SUBJECT: Forwards draft response to NRC Question 130.050 (turbine
 missile study) & revised FSAR pages. All encl info will
 be incorporated into Amend 23.

Subject: NUCLEAR PROJECT NO. 2
NRC QUESTION 130.050
TURBINE MISSILE STUDY

WNP-2

Q. 130.050
(Q220.001)
(3.5.1)

FIGURE 3.5-33

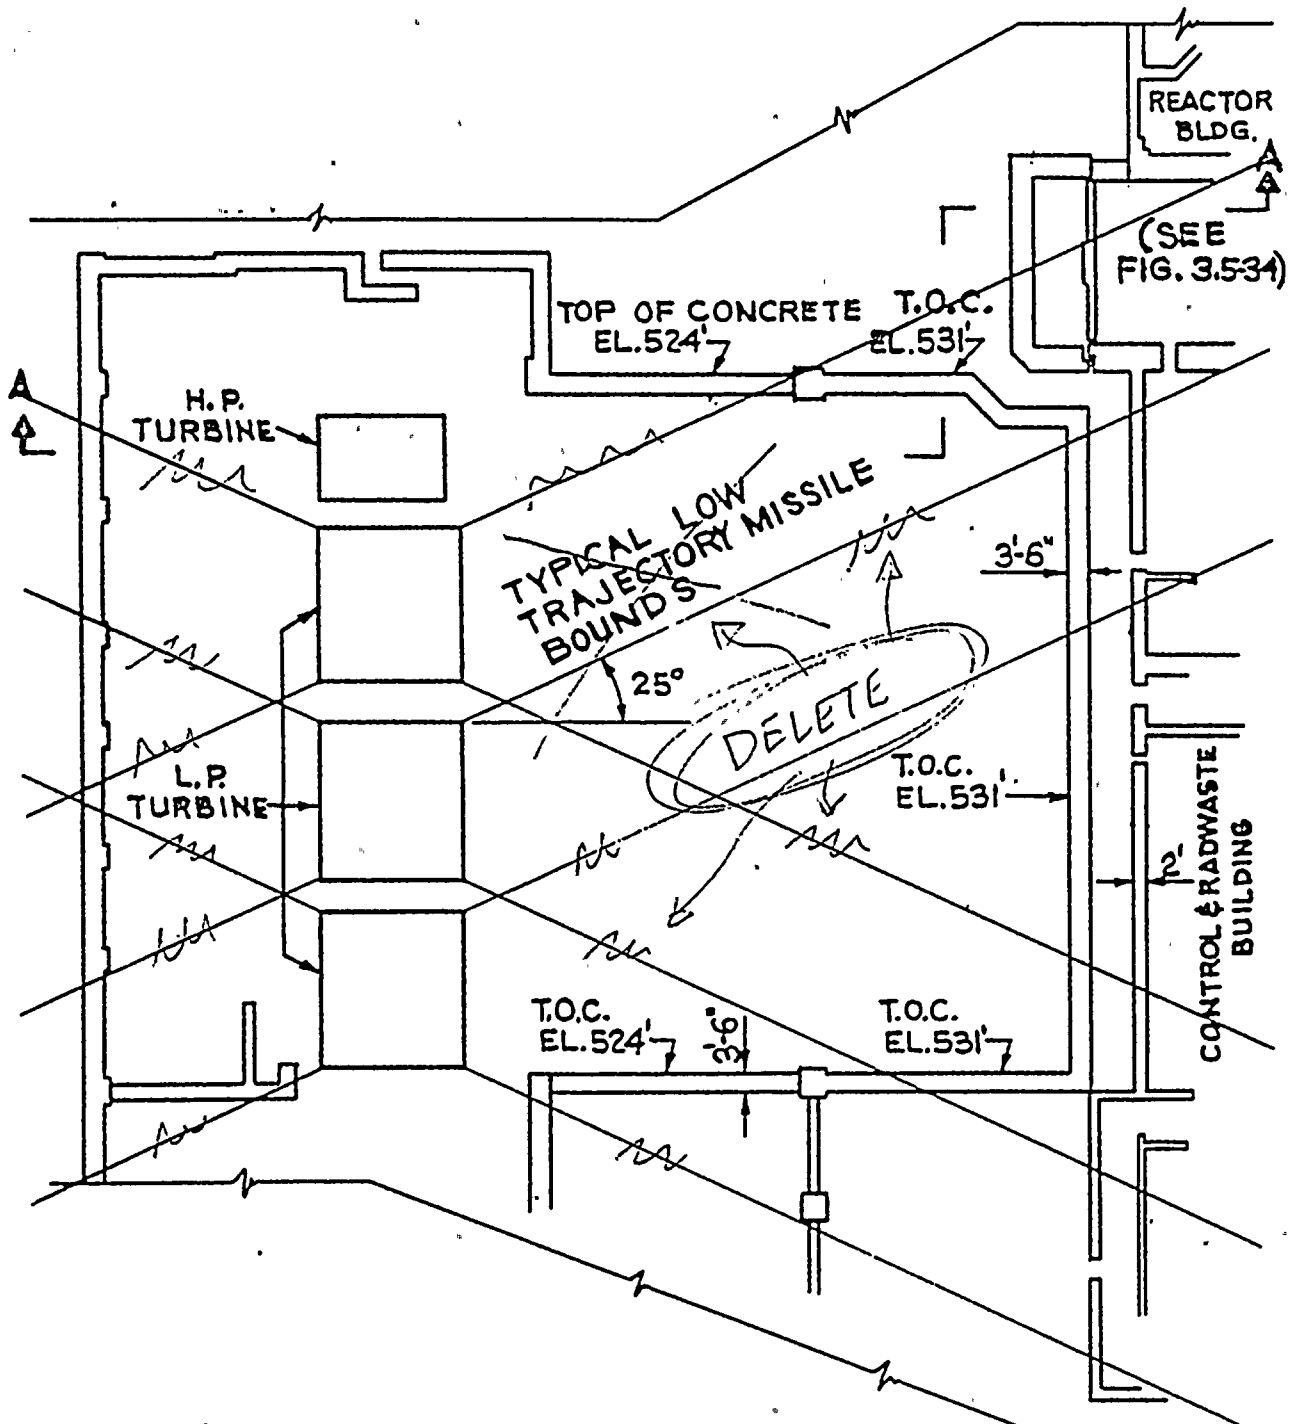
(Deleted)

~~LOW-TRAJECTORY MISSILES~~
~~AT CATASTROPHIC FAILURE~~
~~SPEEDS 181% DESIGN SPEED~~

Figure 3.5-33 shows the turbine generator layout relative to safety-related plant structures and turbine missile target areas. Also shown on this drawing is the reinforced concrete shield wall which acts as a barrier for protection of some safety-related targets from postulated low trajectory turbine missiles. A cross-sectional view through the turbine building and reactor building is shown in Figure 3.5-34 to indicate relative elevations of the turbine and target areas. See Figure 1.2-5 for a general arrangement drawing of the turbine building, reactor building, and control building at the turbine operating floor elevation.

FIGURE
3.5-34

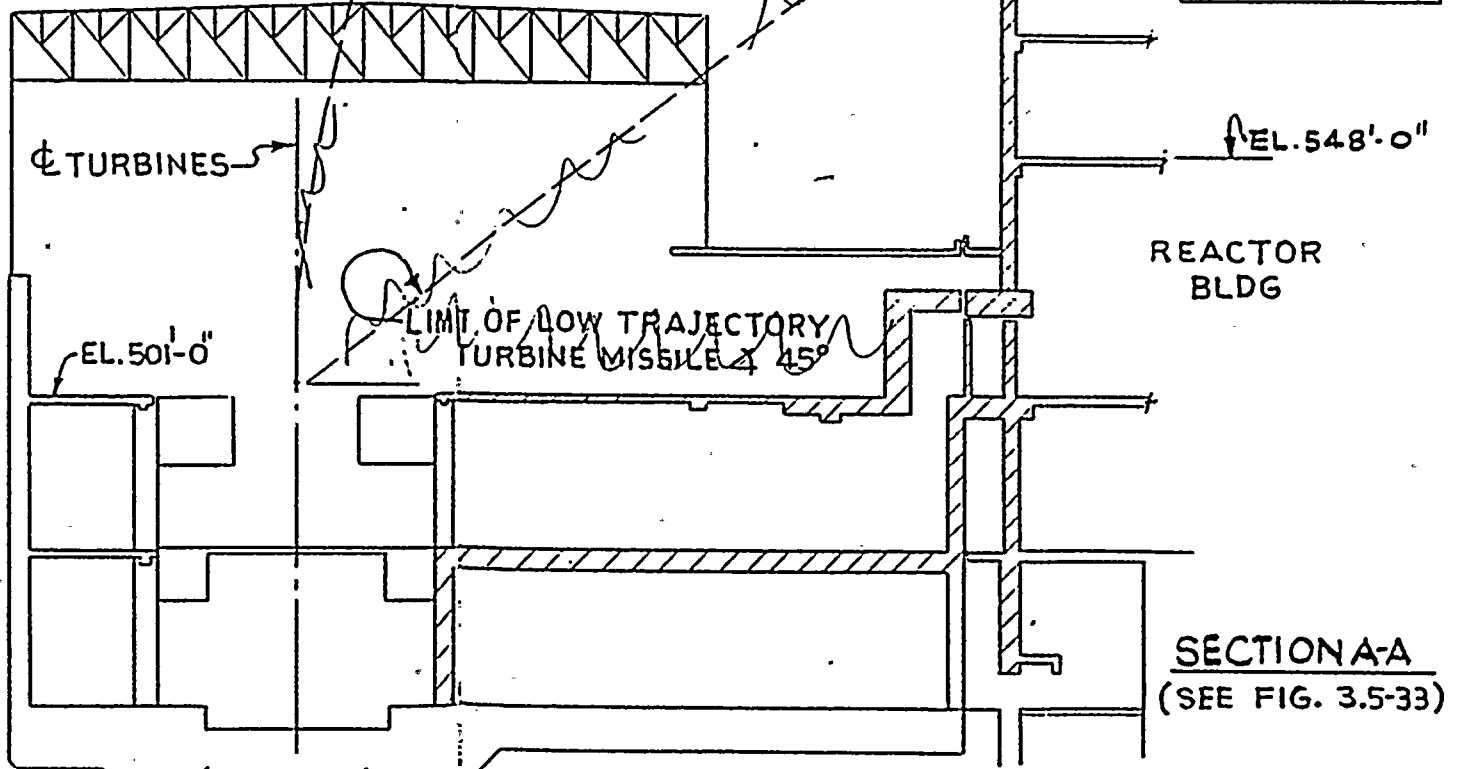
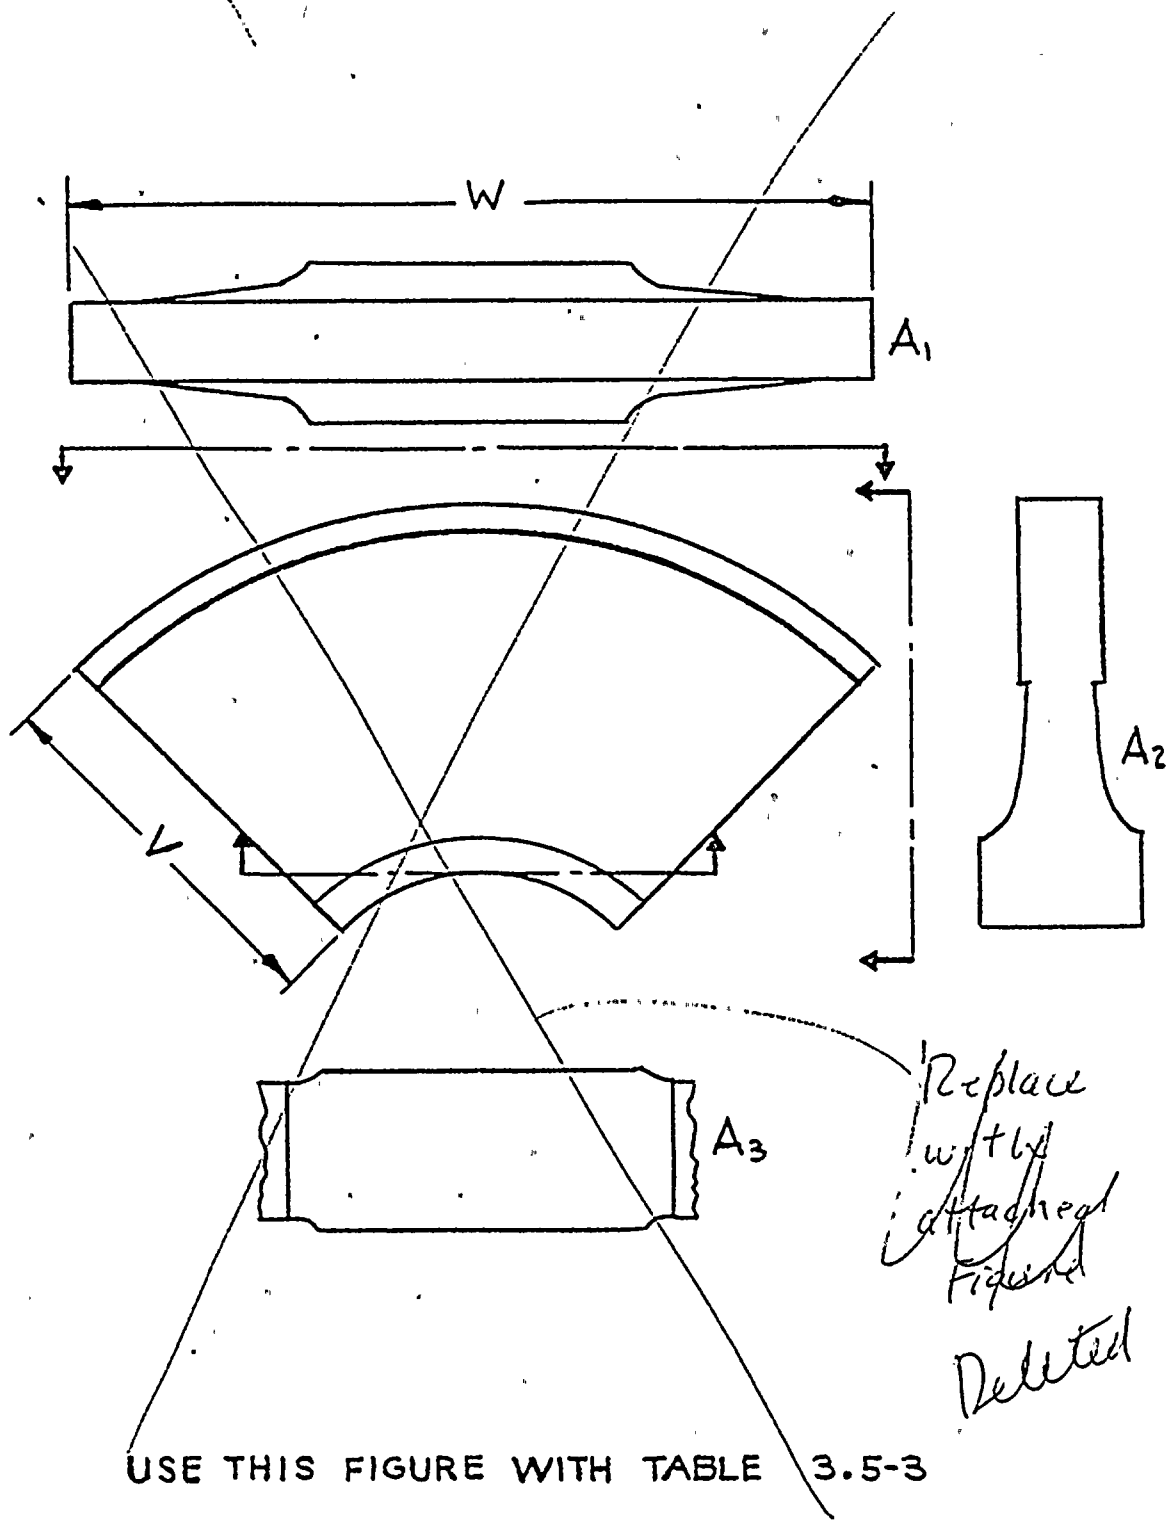
DELETED

~~FURNACE~~
TURBINE MISSILE BARRIERS

*Replace
with
attached
figures
Deleted*
